P802.1CB Layering Issues

Norman Finn
Cisco Systems

May 19, 2015

Figure F-6 Ladder Redundancy

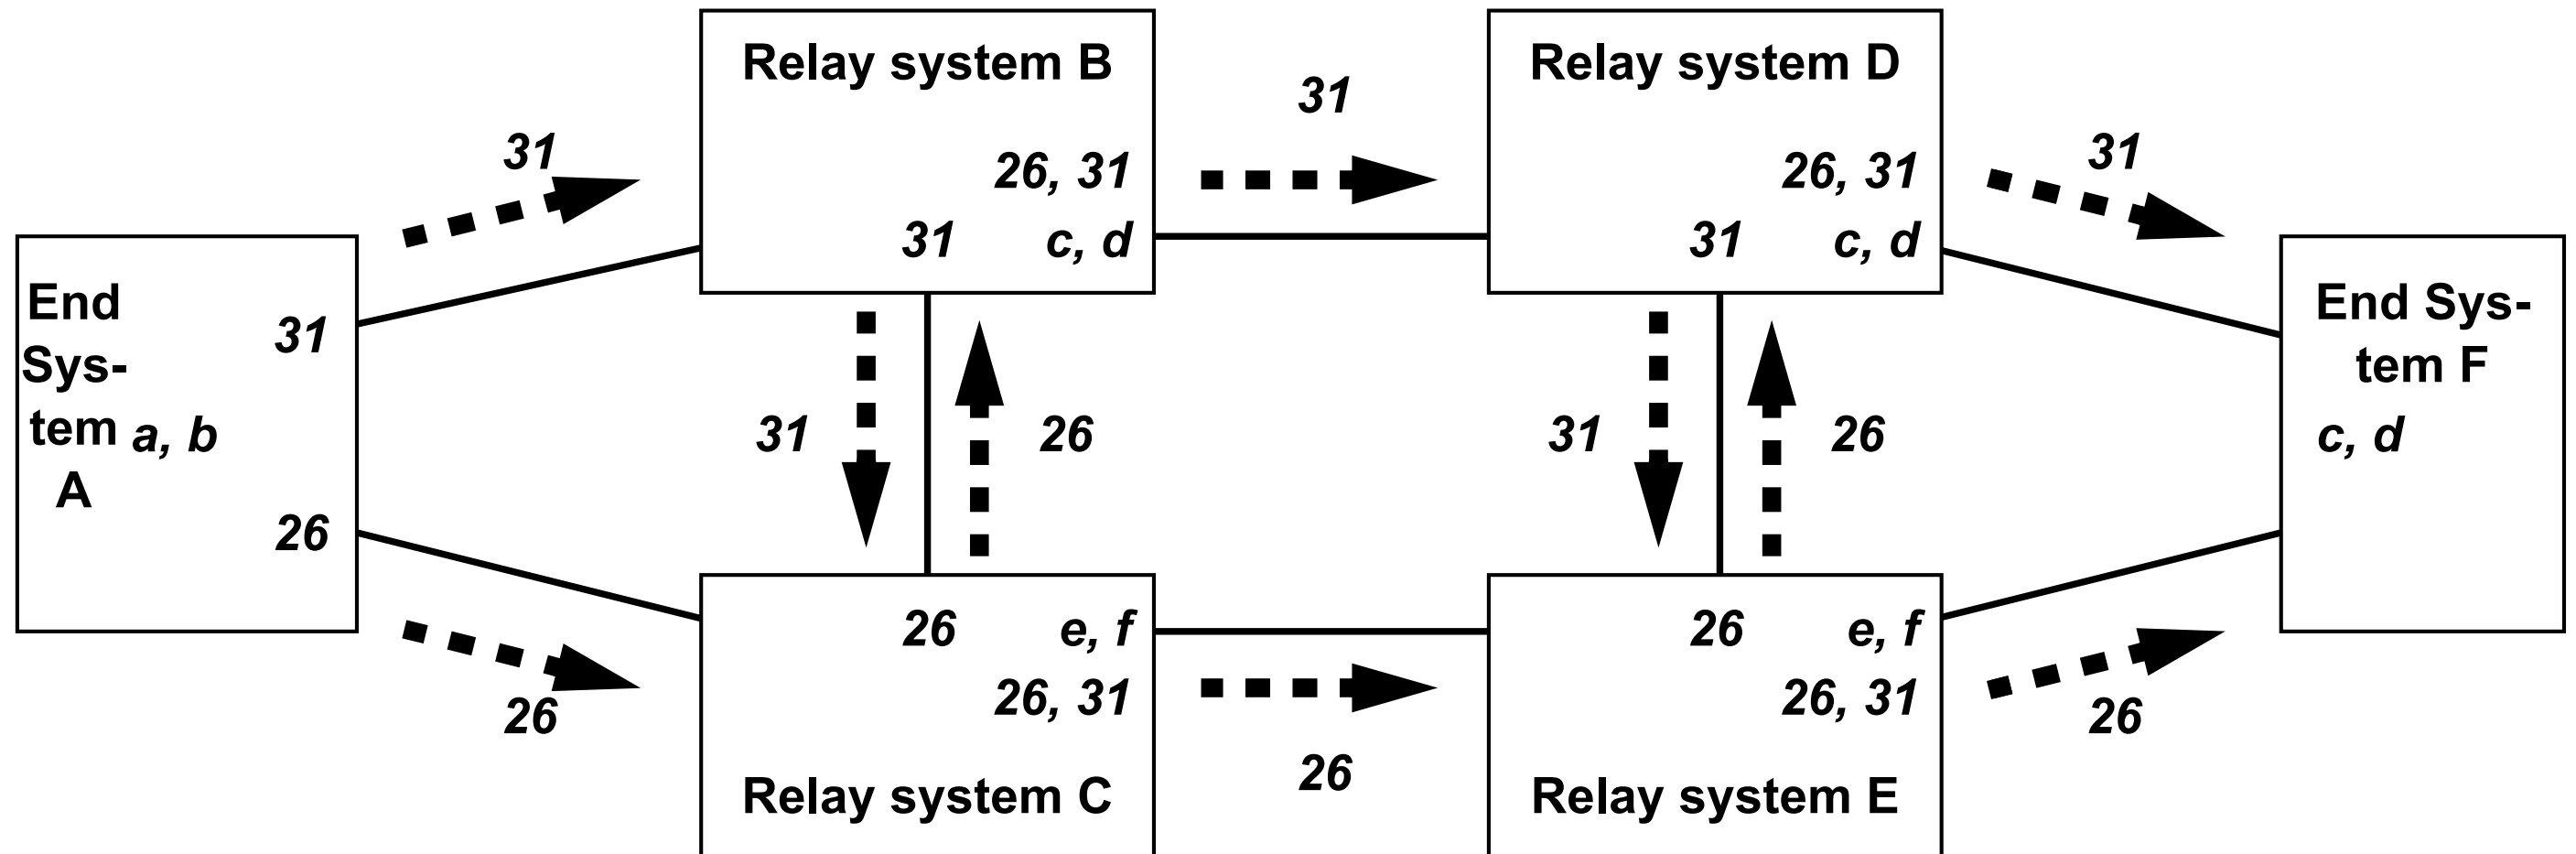
Current diagram for ladder redundancy

Figure F-6 Ladder Redundancy

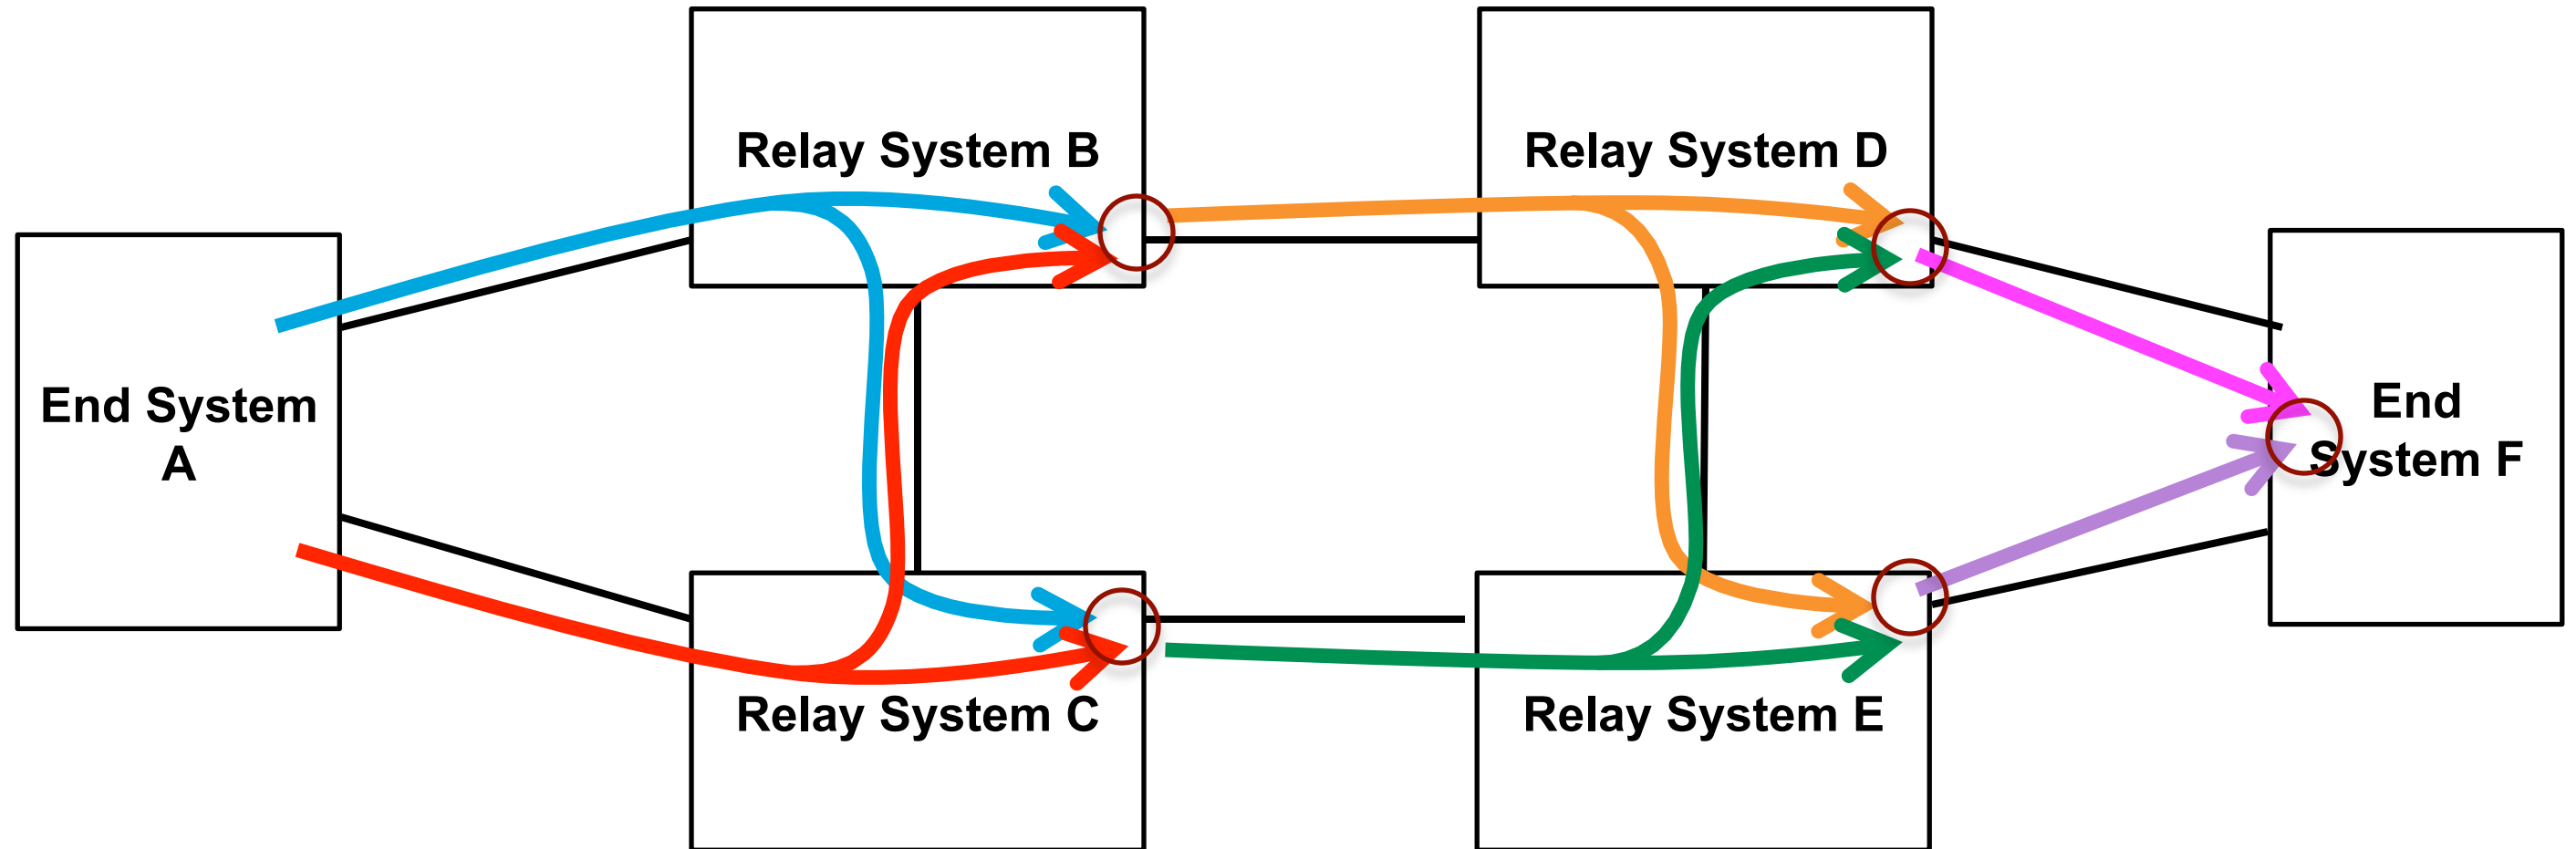
Perhaps a better diagram for ladder redundancy

- We seem to agree that this is what we want to happen.

Figure F-4—Protocol stack for relay system F in Figure F-1

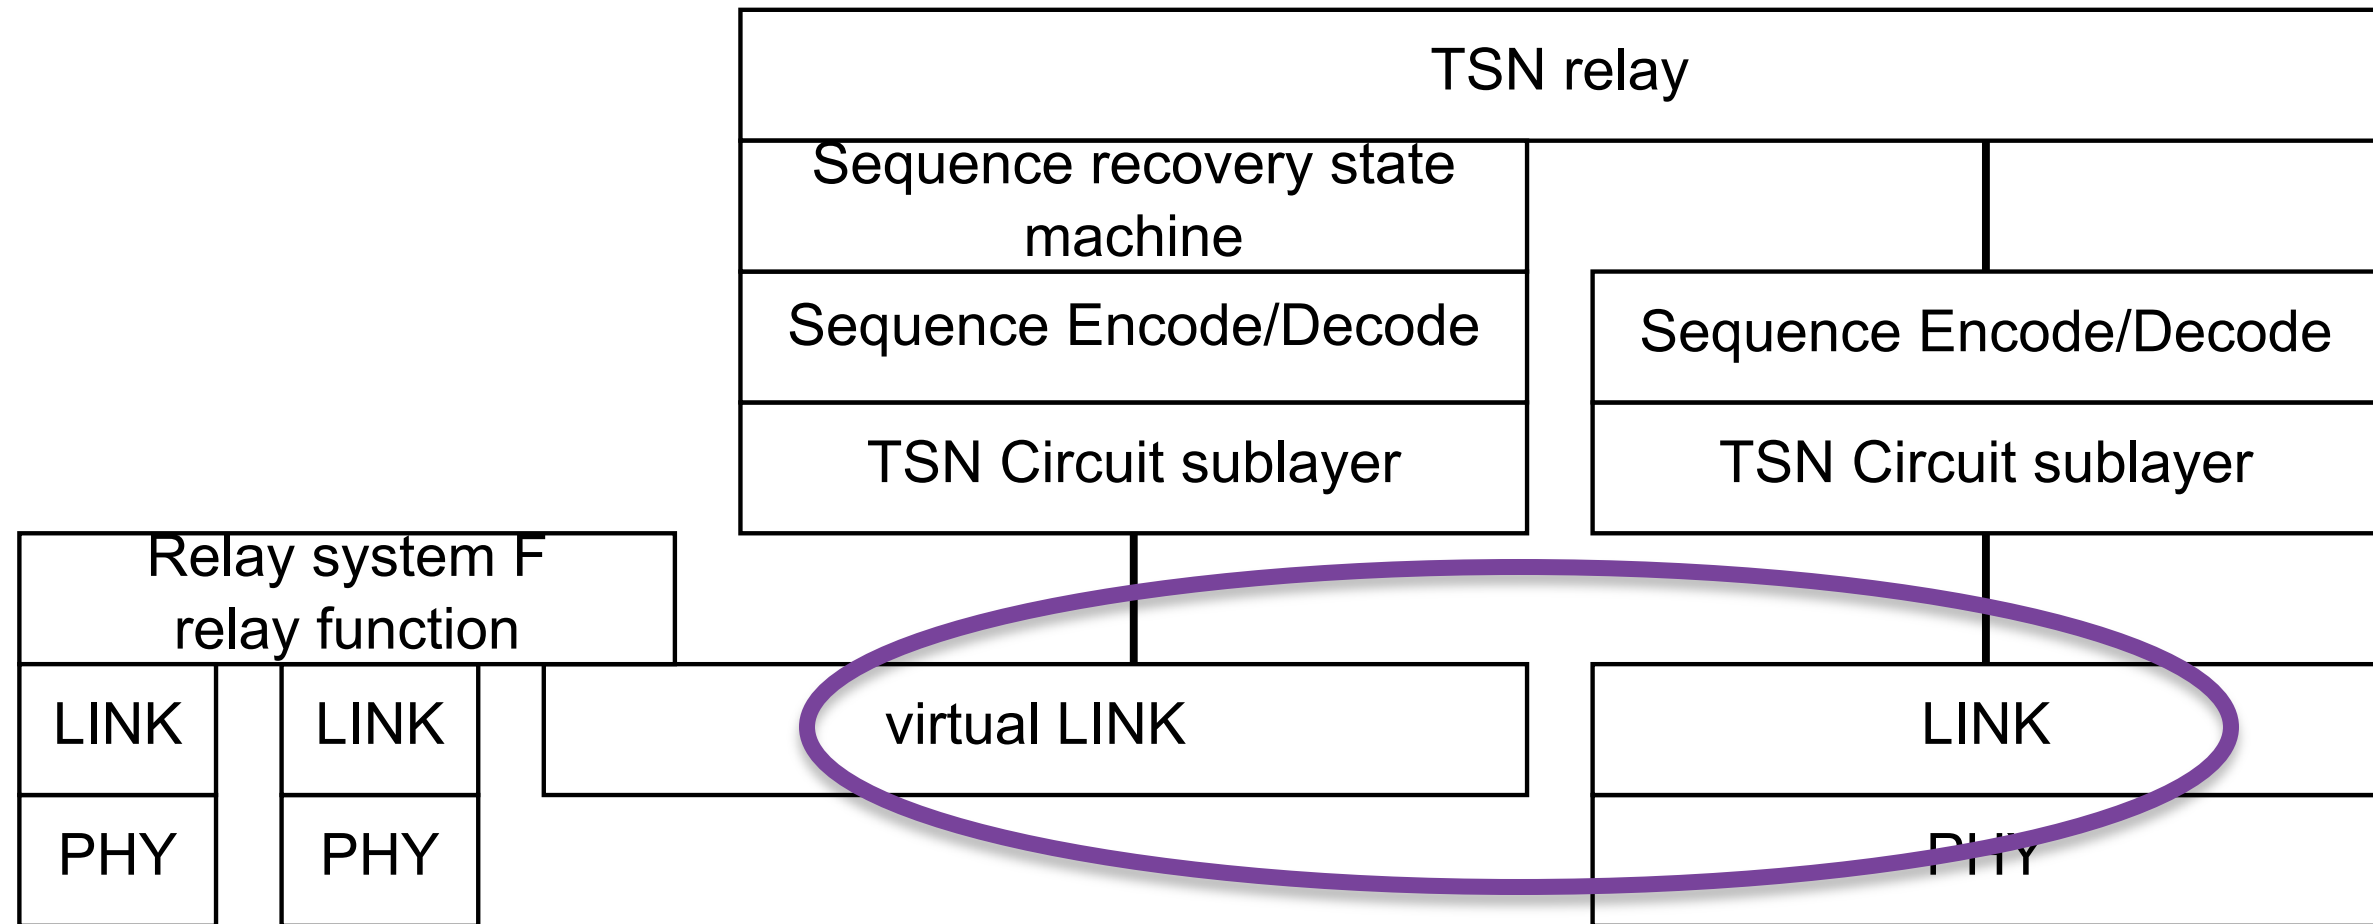
- **Problem:** Where is the **non-TSN traffic** in the “TSN relay”?

- **One answer:** A **Non-TSN relay** keeps the non-TSN traffic where it belongs.
